NEW SUMMARY OF SUBMISSIONS
Local Planning Policy 2.2
Residential Development Standards SJ2963
Responsible Officer: Lauren Dujmovic Advertising Date: 22/01/2020 – 14/02/2020

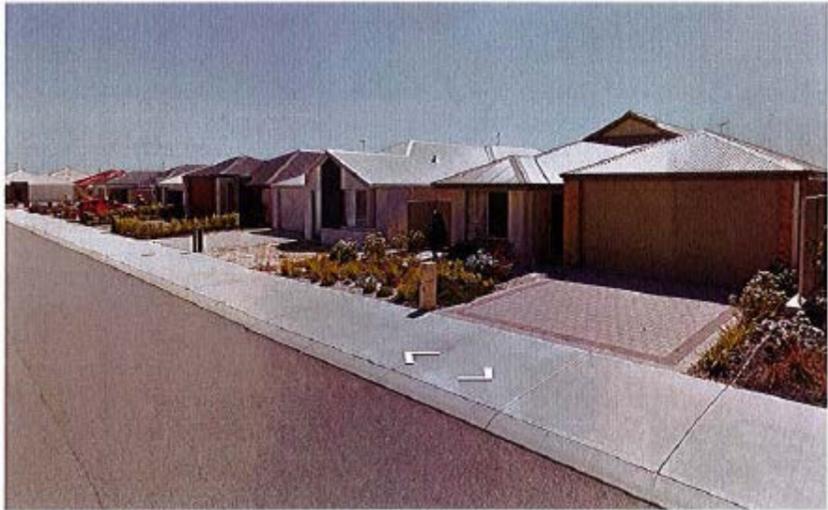
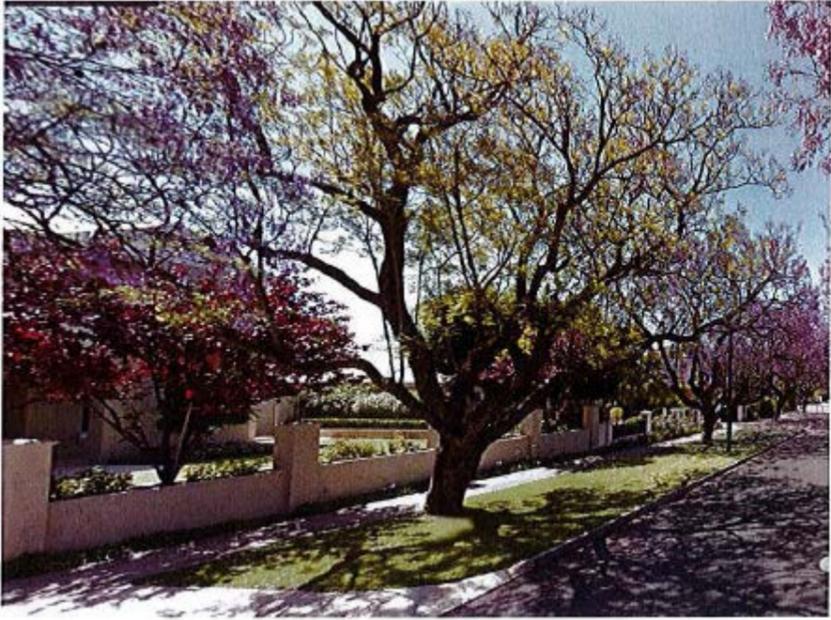
Submitter	No	Submitter Comments	Officer Comment	Officer Recommendation
		<p>Byford, it becomes crucial to provide quality outdoor environments that can promote healthy living. It is considered that a courtyard of 16m² is adequate and a functional outdoor living area.</p> <p><u>Garage Setback and Width and Vehicular Access</u> Front Load R25- R60 As long as SJ Shire continues to be a car-dependent focused local authority, cars as the primary mode of transport will continue to prevail and dominate the streetscape in every corner of the suburbs. The proposed setbacks for front-loaded lots at 4.5m or 5.5m depending on the footpath location will be difficult to monitor and enforce. The proposal will encourage developers to provide a footpath next to the road kerb like the example below.</p>  <p>This compares with a footpath close to the lot boundary with uninterrupted verge parking as indicated below.</p>
